# CERTIFICATE OF APPROPRIATENESS

**ITEM D15**  
HPO File #: HP2025\_0362

415 Harvard  
Houston Heights South

**Proposal:** Alteration – Single Family Residential

### Eave Height (Addition and New Construction)

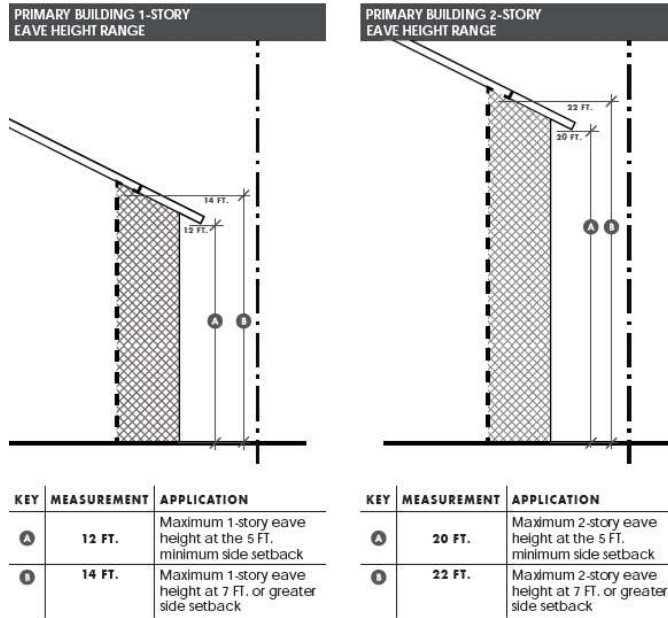
Proposed eave height: 22'-0"

### Front Setbacks (New Construction)

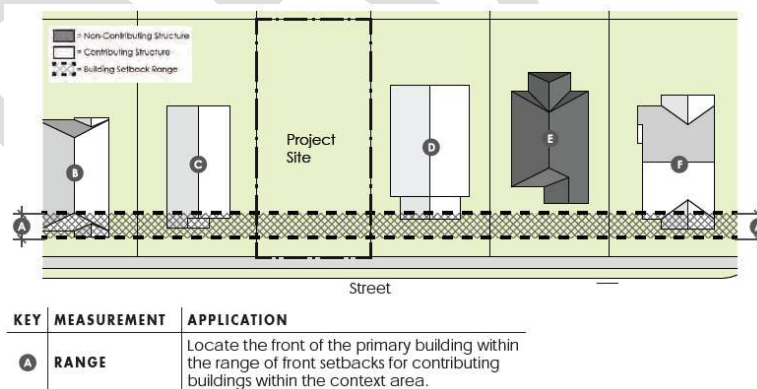
Proposed front setback: 22'-9" (existing)

**Front Wall Width and Insets (New Construction)**

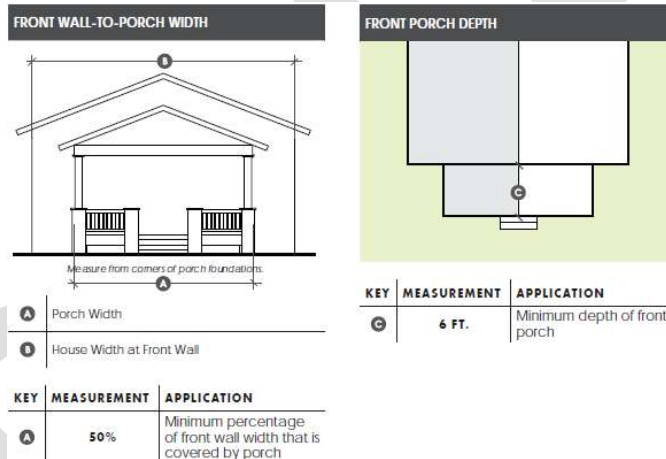
Max front wall width: N/A

Max front wall depth: N/A

Building Wall (Plate) Height (Addition and New Construction)

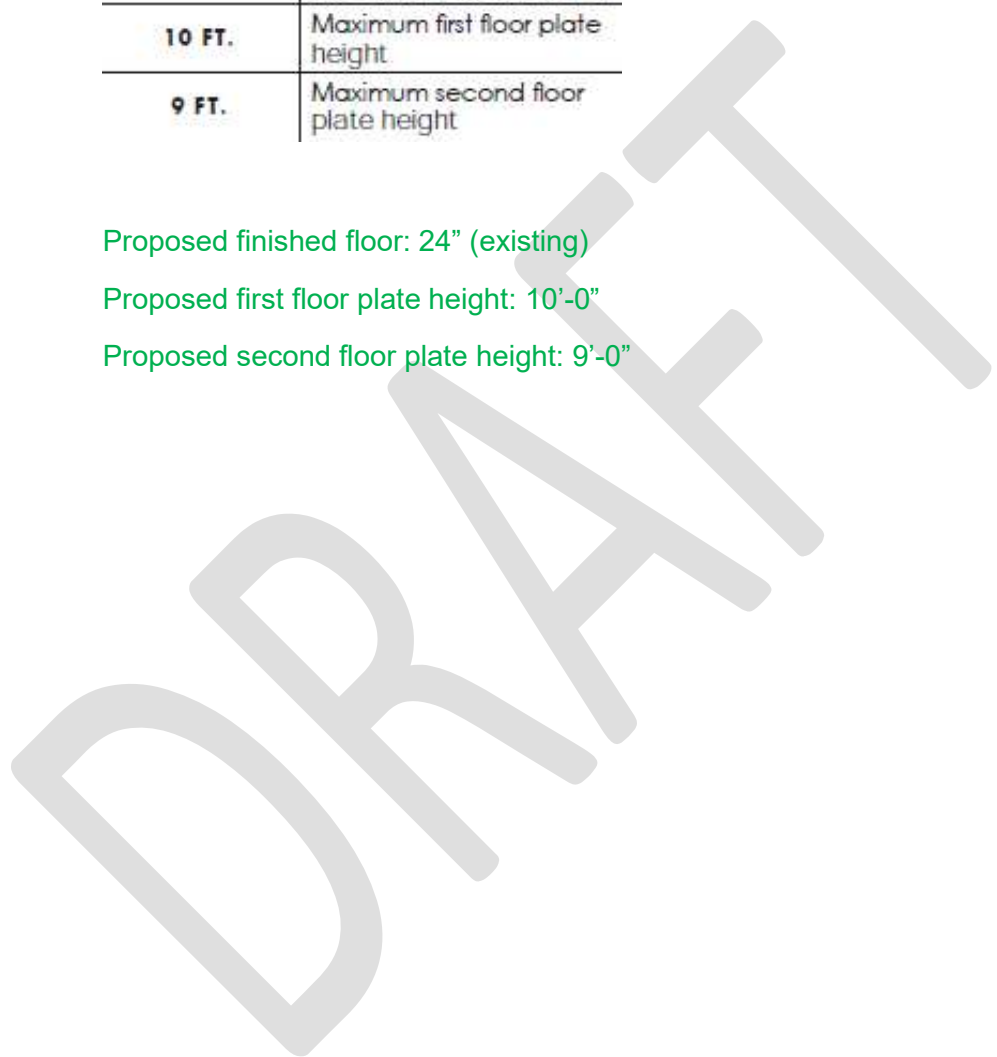
Proposed finished floor: 24" (existing)

Proposed first floor plate height: 10'-0"

Proposed second floor plate height: 9'-0"

## ATTACHMENT A

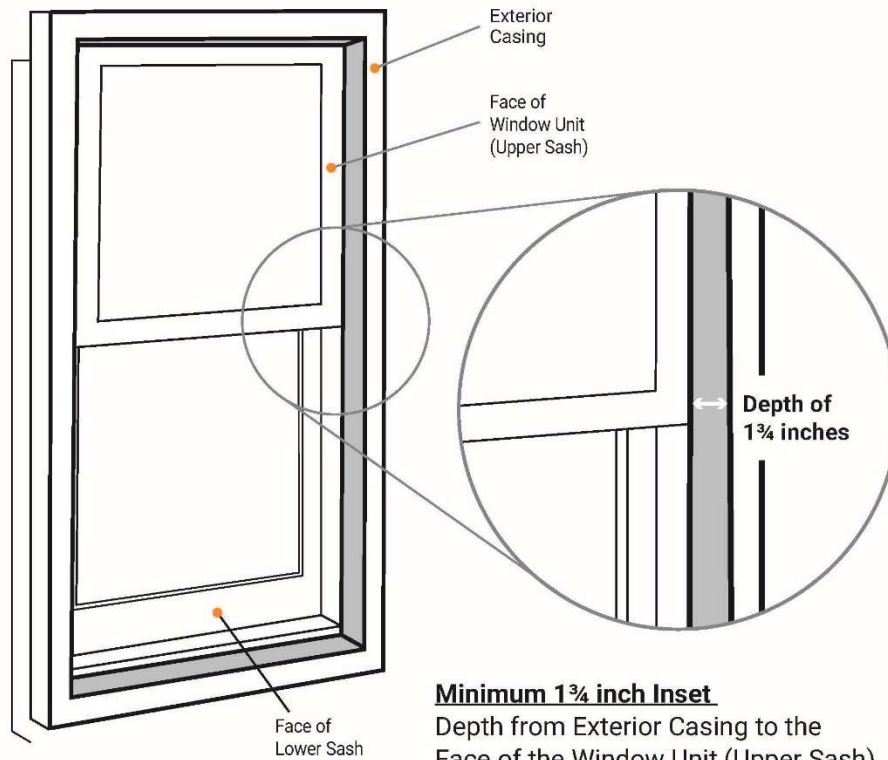
- Repair existing siding as needed with in kind materials.
- All new windows need to be inset and recessed. See Attachment A for details.
- Repair existing fascia and soffits, with in kind material.

**Minimum 1 3/4 inch Inset**  
Depth from Exterior Casing to the Face of the Window Unit (Upper Sash)

Windows must be 1-over-1  
(equally horizontally divided)

1 3/4 inch minimum inset for Fixed Window
